Project Location:	Bishop O'Dowd High School: 9500 Stearns Avenue; 0 Seneca Street. The property is bounded by 98 th Avenue, Burr Street and Seneca Street.
Assessor's Parcel Numbers:	043A467000106; 043A475500117; 043A475500107; 043A476000402; 043A476000300.
Proposal:	To construct a multi-use sports field, surface parking lot and access road. (The sports field and parking lot would be constructed on the former EBMUD water tank reservoir. The main access road for the project would be constructed on the Bishop O'Dowd High School property off 98 th Ave.)
Project Applicant/ Telephone:	Mark Knoerr, CSDA Design Group / (415) 689-9800
Property Owners:	Bishop O'Dowd High School / East Bay Municipal District (EBMUD)
Case File Number:	PLN17185
Planning Permits Required:	Major Conditional Use Permit for development over 1-acre in size; Minor Conditional Use Permit for expansion of school activities; Regular Design Review for new site and building construction; and Minor Variance for light poles exceeding the maximum allowed height.

CITY OF OAKLAND PLANNING COMMISSION

Case File: PLN17185
Applicant: Mark Knoerr, CSDA Design Group
Address: 9500 Stearns Ave/0 Seneca St
(bounded by 98th Ave, Stear

SITE PLAN

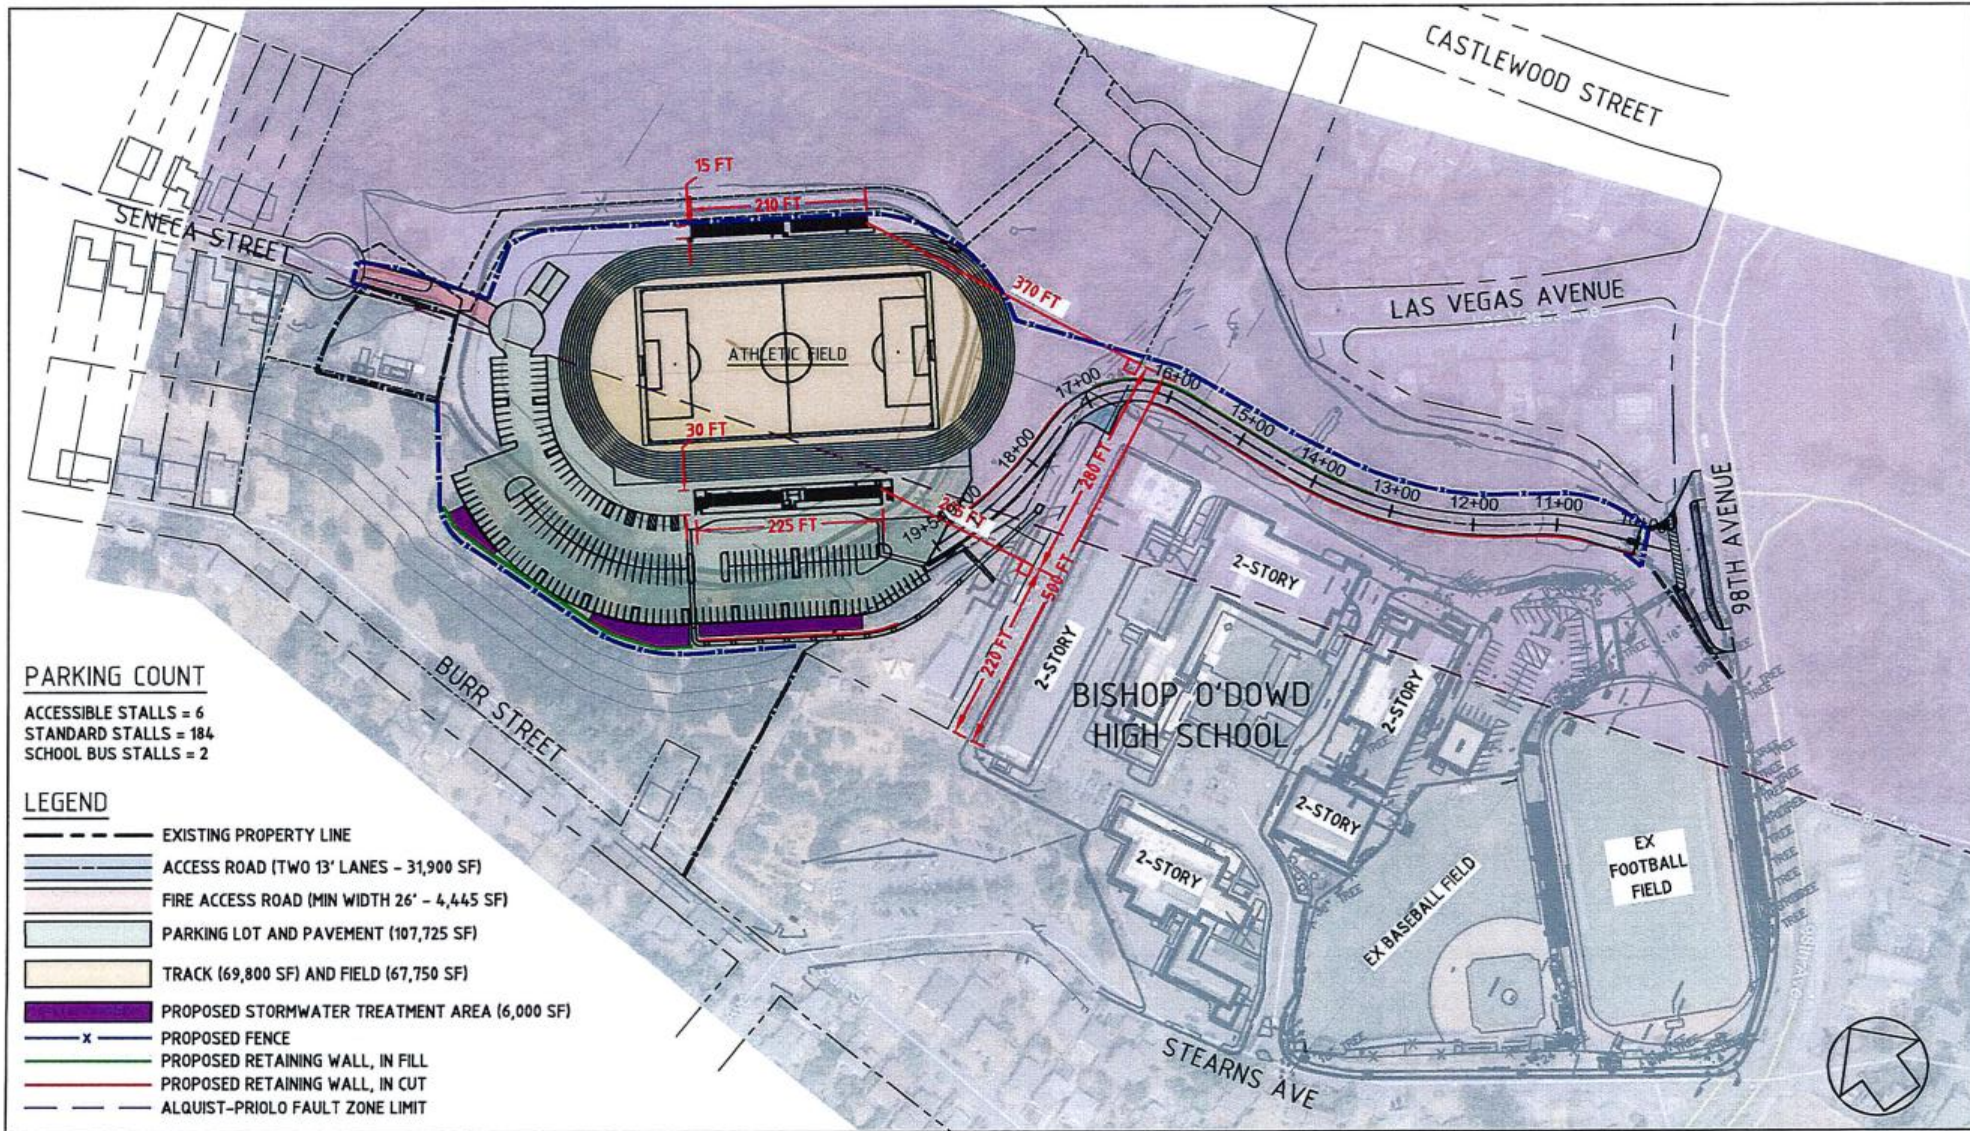
Staff recommends the applicant study the feasibility to reconfigure the parking lot to reduce the size and number of parking spaces in the portion of the parking area, located along the west. It is recommended that a portion of the proposed parking is moved instead to the north side of the sports field.

- Reduce and reconfigure the proposed parking lot, so it is located farther from the surrounding residences.
- Provide alternative design options such as hardscape/landscaping to reduce noise.

SHEET CONTENT:
PHOTOMETRICS - FIELD

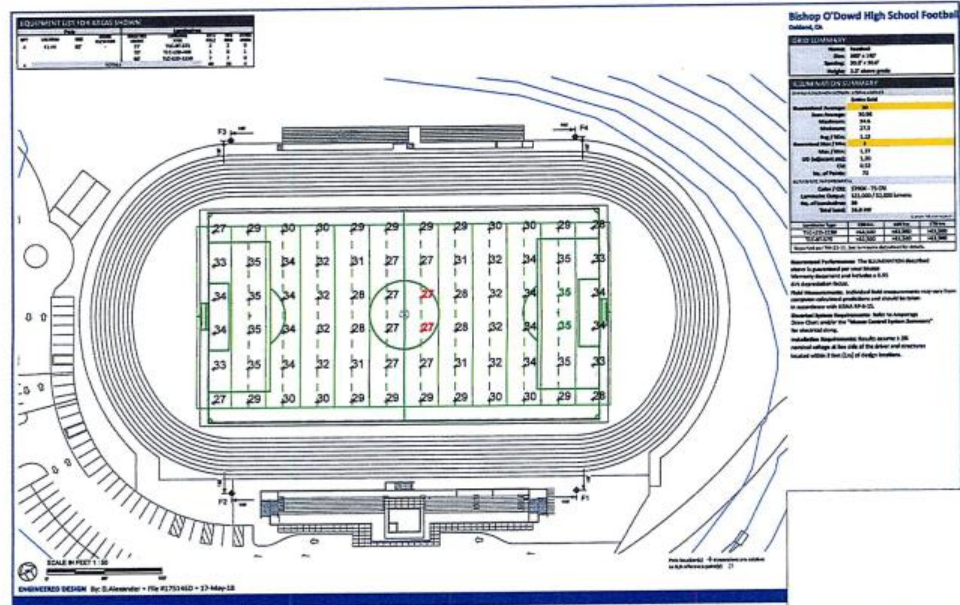
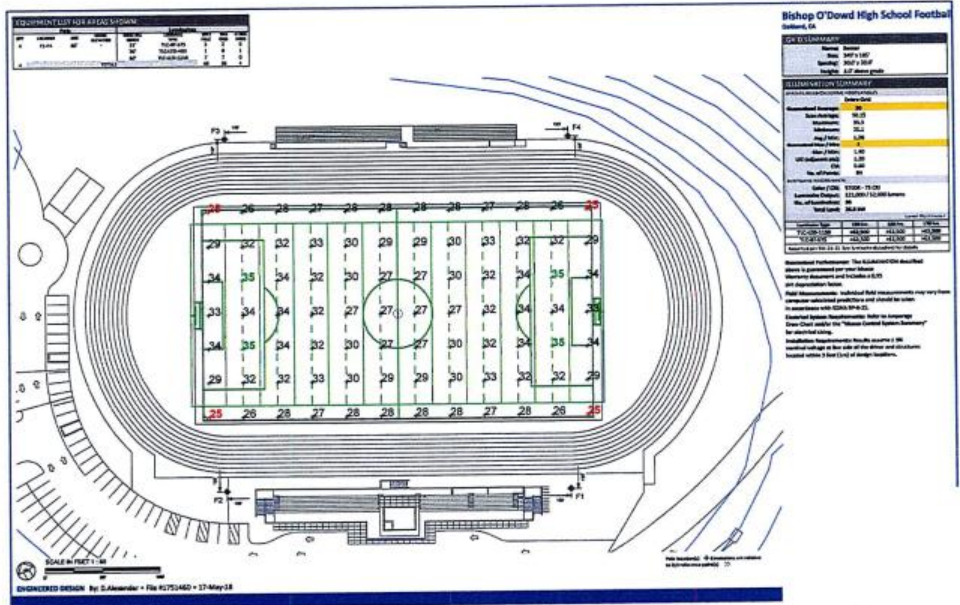
Four 80 foot tall LED light poles are proposed around the sports field. The photometric plans show technical data, but do not show clearly whether the light exposure extends over the property line or into the adjacent properties. The plans also lack elevation details of the light poles to assess height and visibility from surrounding areas. Staff anticipates further light analysis will be provided for review when the environmental study is completed.

Staff suggests that at least schematic plans demonstrate site, elevation and 3D view plans or images of the light poles and source projecting into the proposed field.
